UNITED STATES OF AMERICA
NUCLEAR REGULATORY COMMISSION

In the Matter of)	
)	
THE CLEVELAND ELECTRIC)	
ILLUMINATING COMPANY, <u>ET AL.</u>)	Docket Nos. 50-440
)	50-441
(Perry Nuclear Power Plant,)	
Units 1 and 2))

APPLICANTS' ANSWERS TO OHIO
CITIZENS FOR RESPONSIBLE ENERGY
INTERROGATORIES 9-1 THROUGH 9-25
AND 9-38 THROUGH 9-52 RELATING TO
ISSUE NOS. 13 AND 15

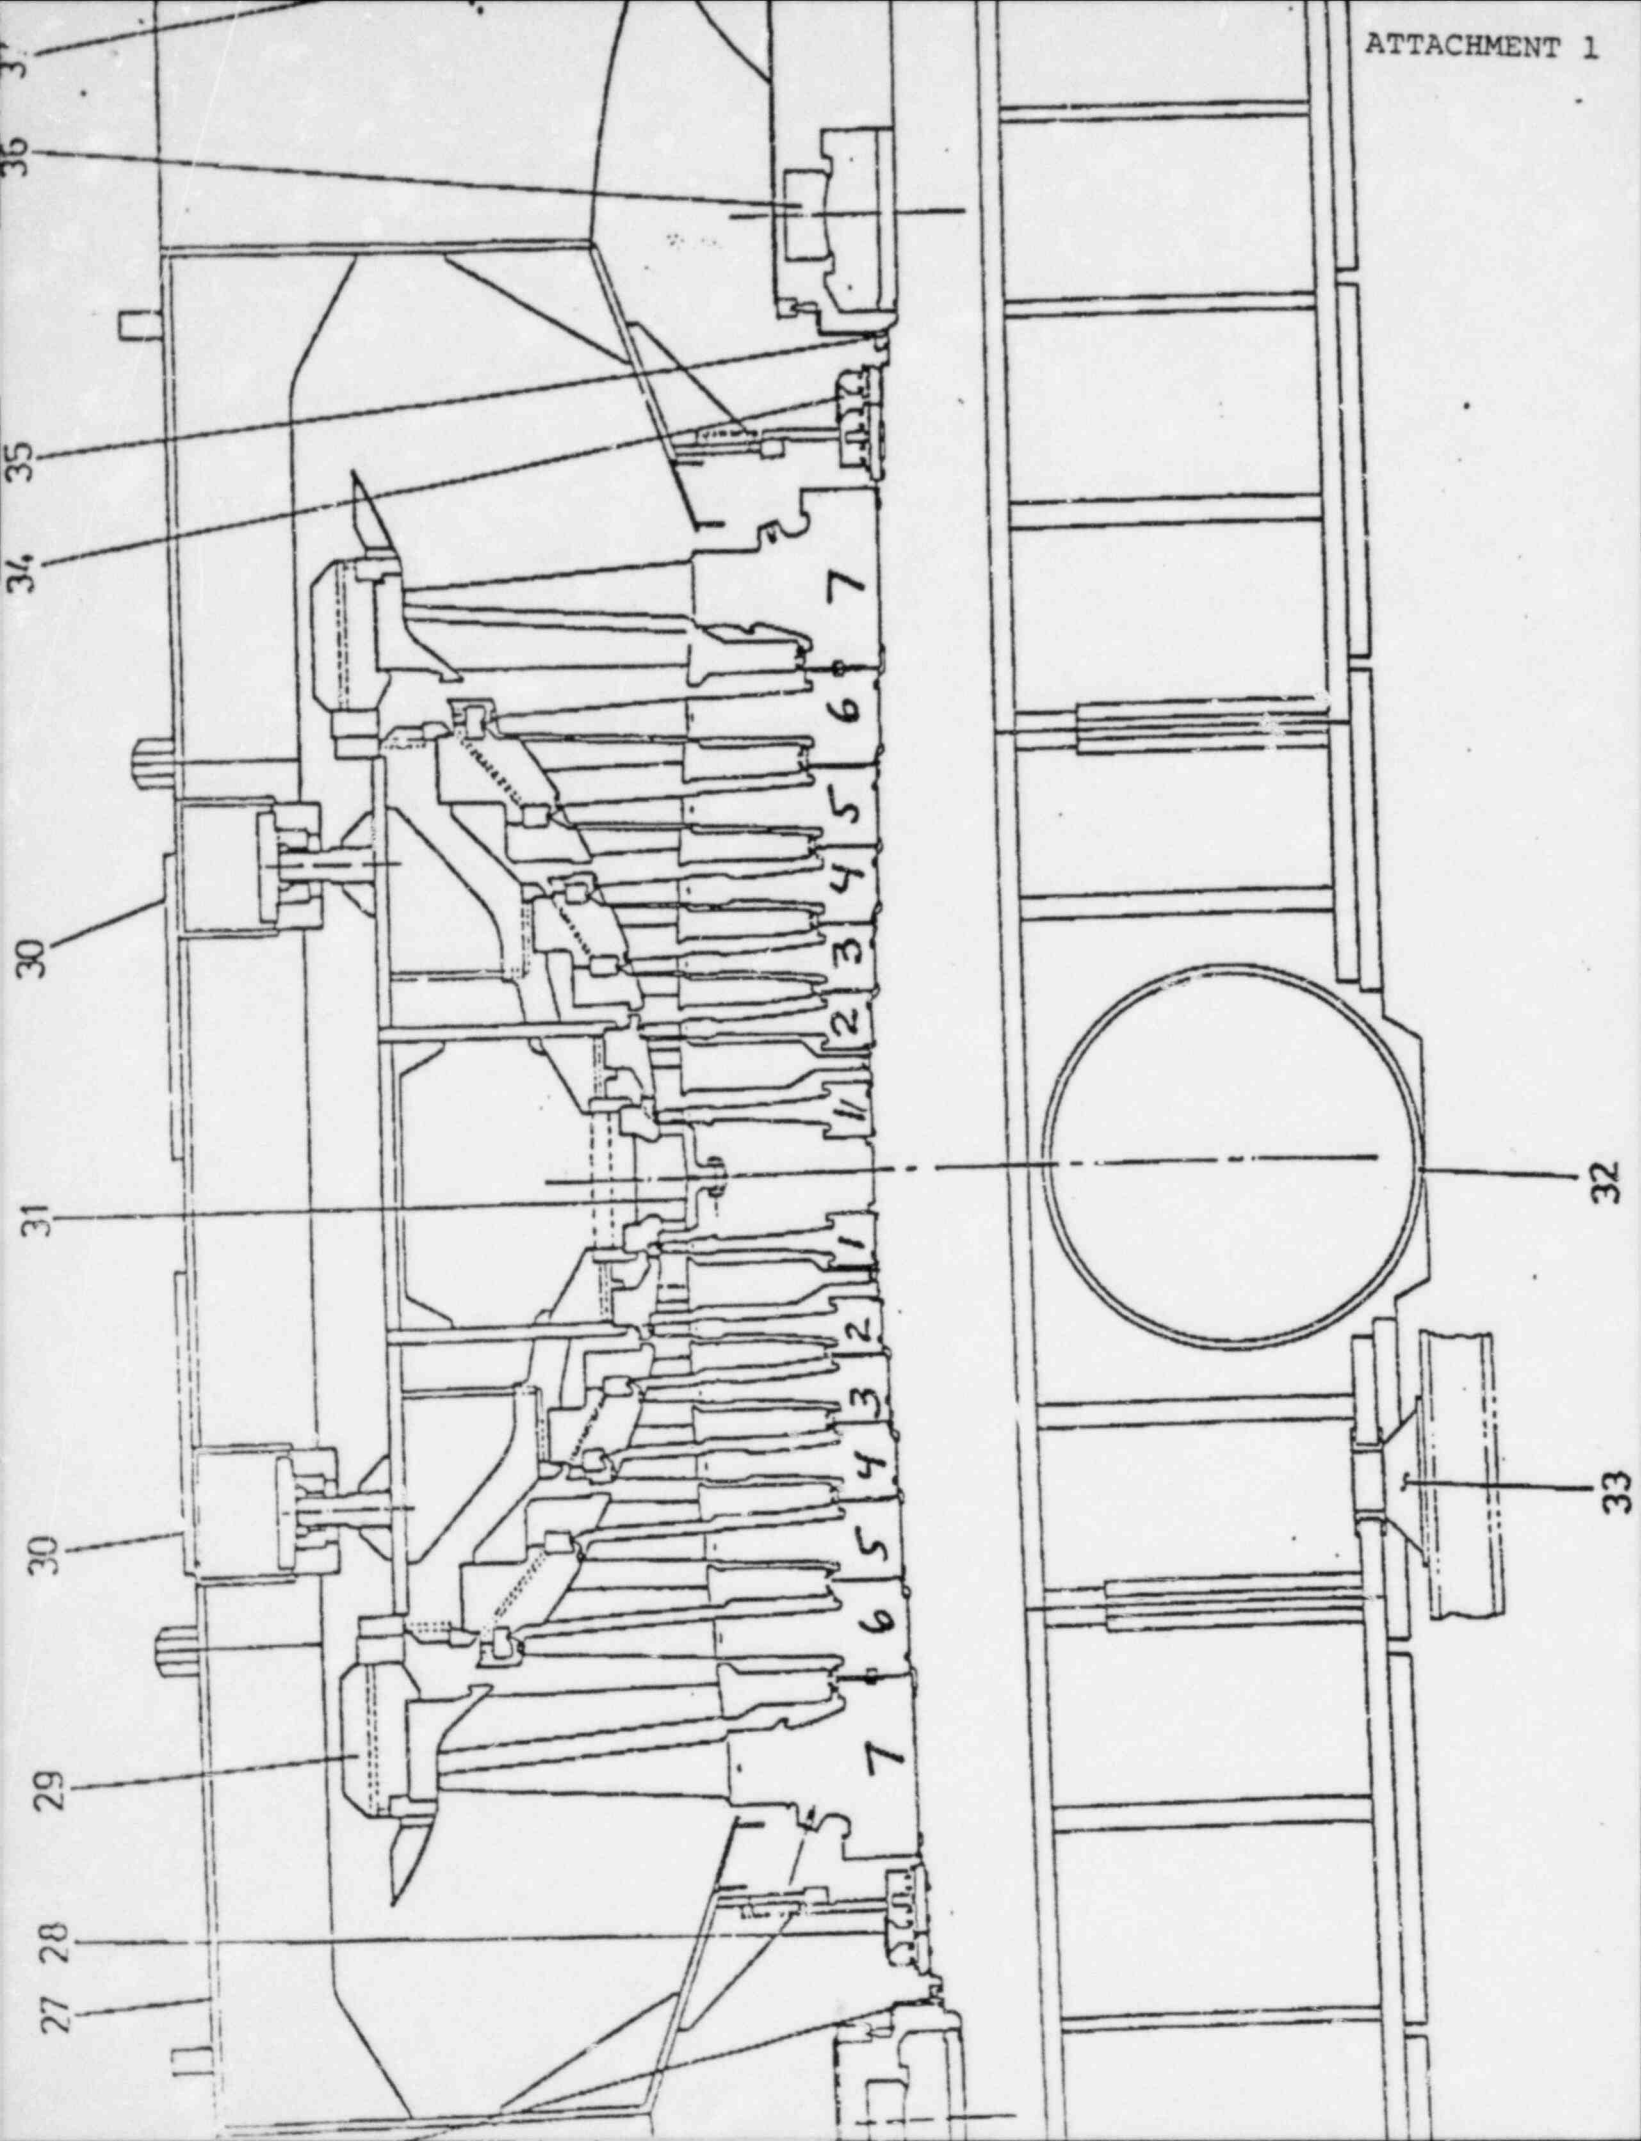
9-17. Provide detailed drawings of the turbine low-pressure stages, showing and identifying the turbine discs and "wheel groups" of Table 2-4 of the Gilbert Report.

A cross section of a low pressure turbine is shown in Attachment 1. The rotor is symmetrical about the vertical centerline. Wheels 1, 2 and 3 make up the first wheel group; and wheels 4, 5 and 6 make up the second group. The seventh wheel by itself is identified as the third group.

TARGET PLATE WITH TELL TALE VALVE

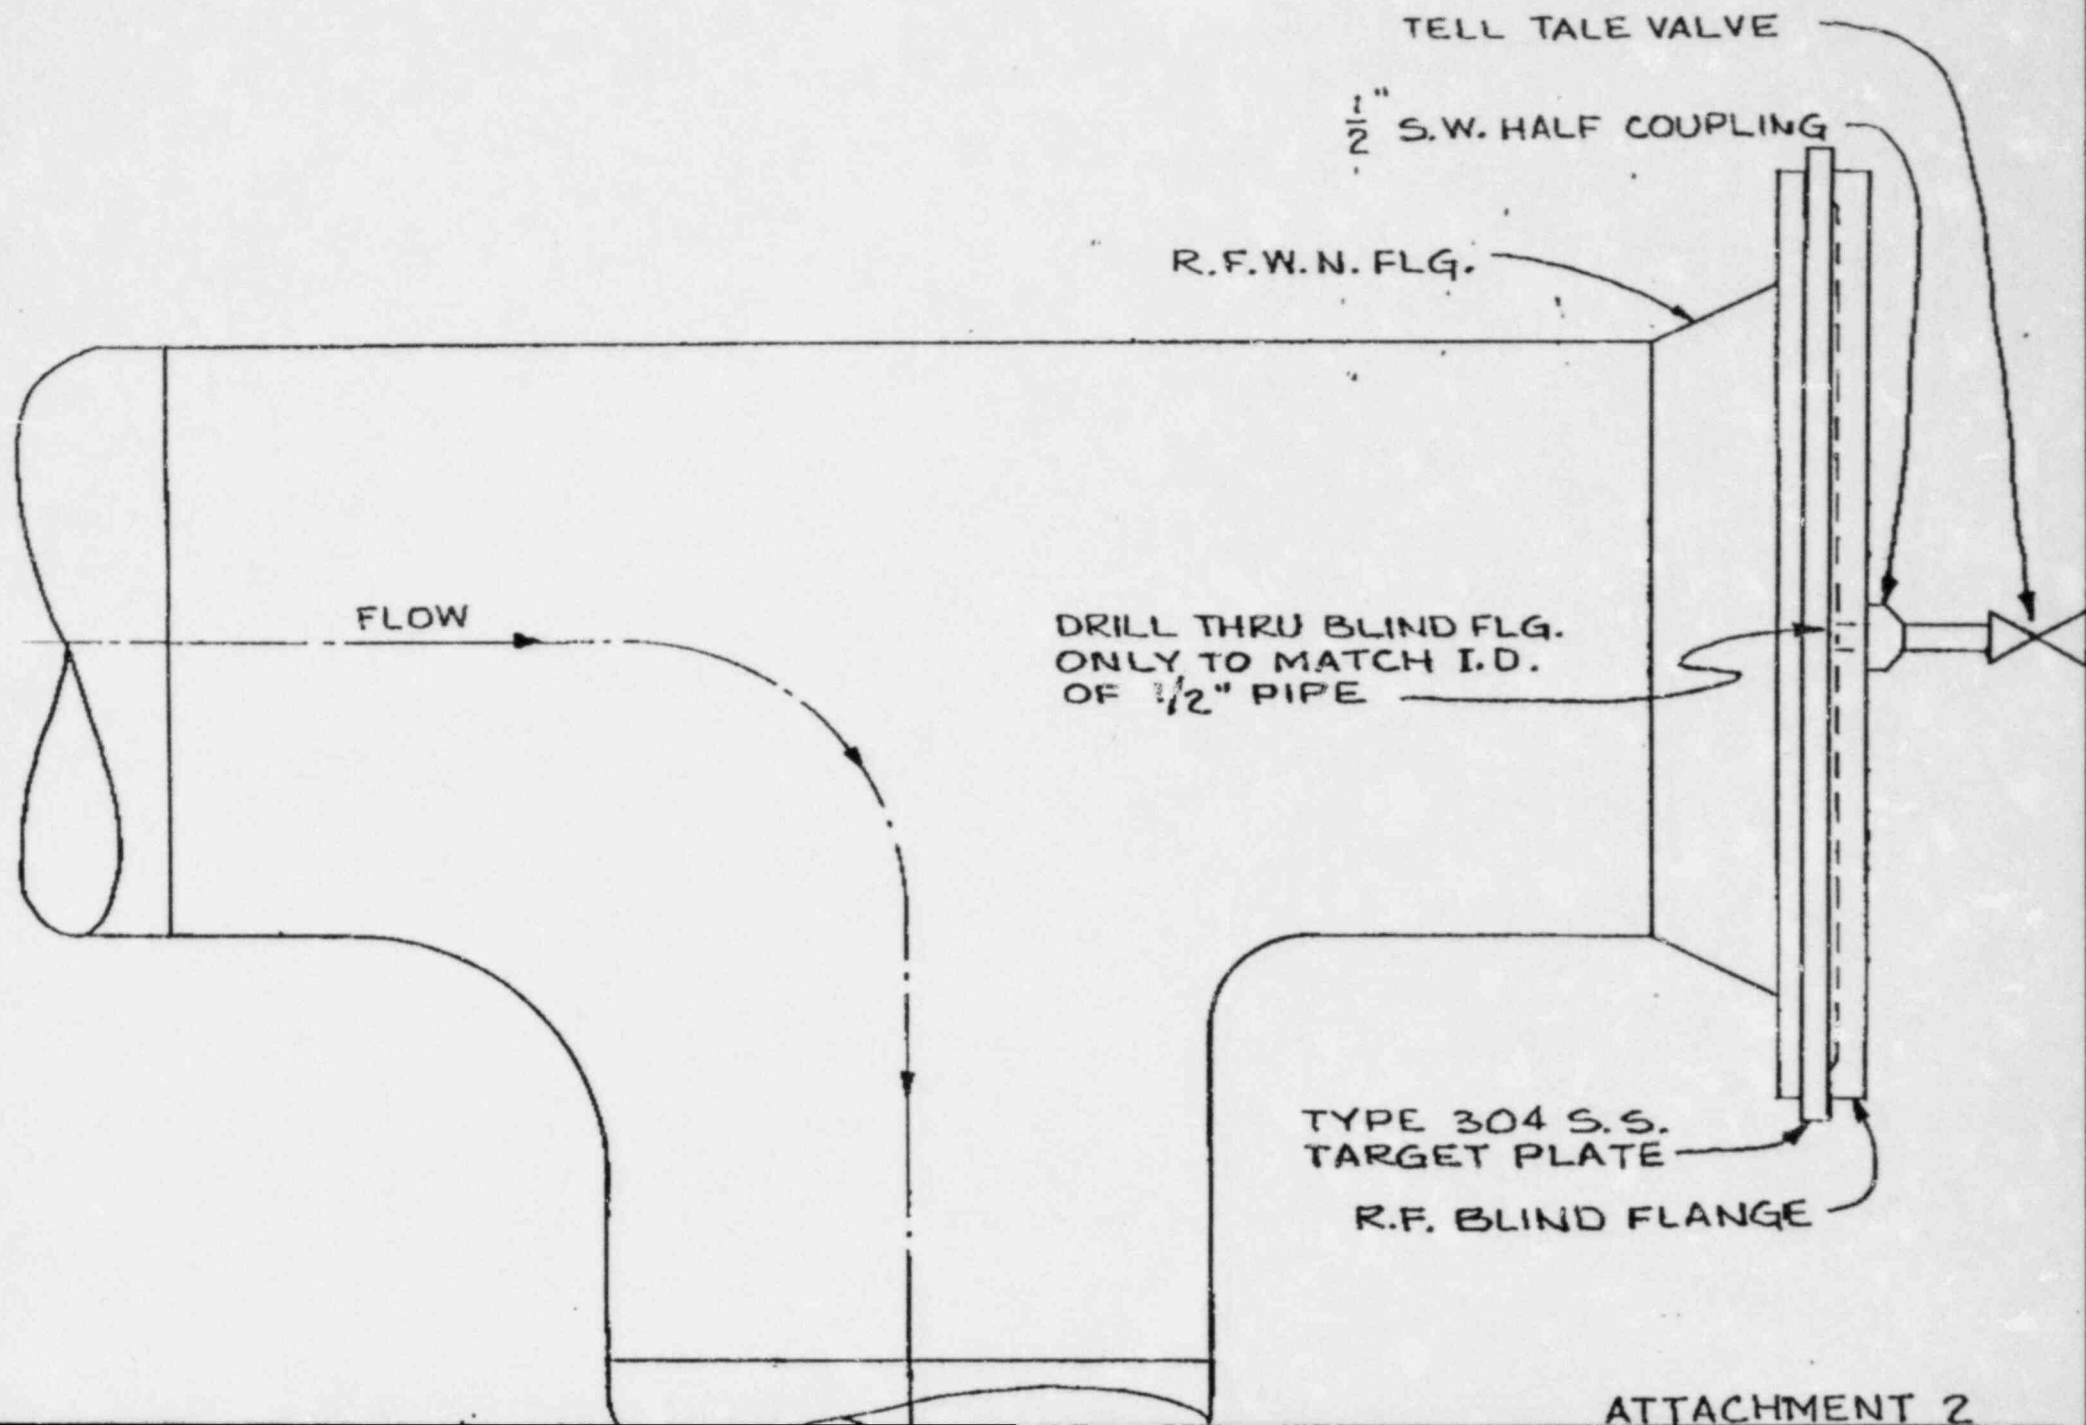
(a) N25/N26 - High Pressure and Low Pressure Heater Drains and Vents. Level will be controlled in the high pressure and low pressure heaters by means of a level control switch which will open a control valve in either a normal or alternate flow path. Downstream of this control valve, severe erosion can occur. This problem has been identified throughout the industry. To minimize the effects of erosion, a criterion

was established that no directional changes in piping would be acceptable between the valve and heater/condenser.

Because of physical limitations, this criterion could not always be followed. Where directional changes occur, 90° elbows were replaced with tee's and target plates with telltales added. See Attachment 2 for details. The stainless steel target plate will act as a wear plate and can be readily removed if necessary. This design has been used very successfully at CEI's fossil fuel plants and has minimized erosion problems in heater drain lines.
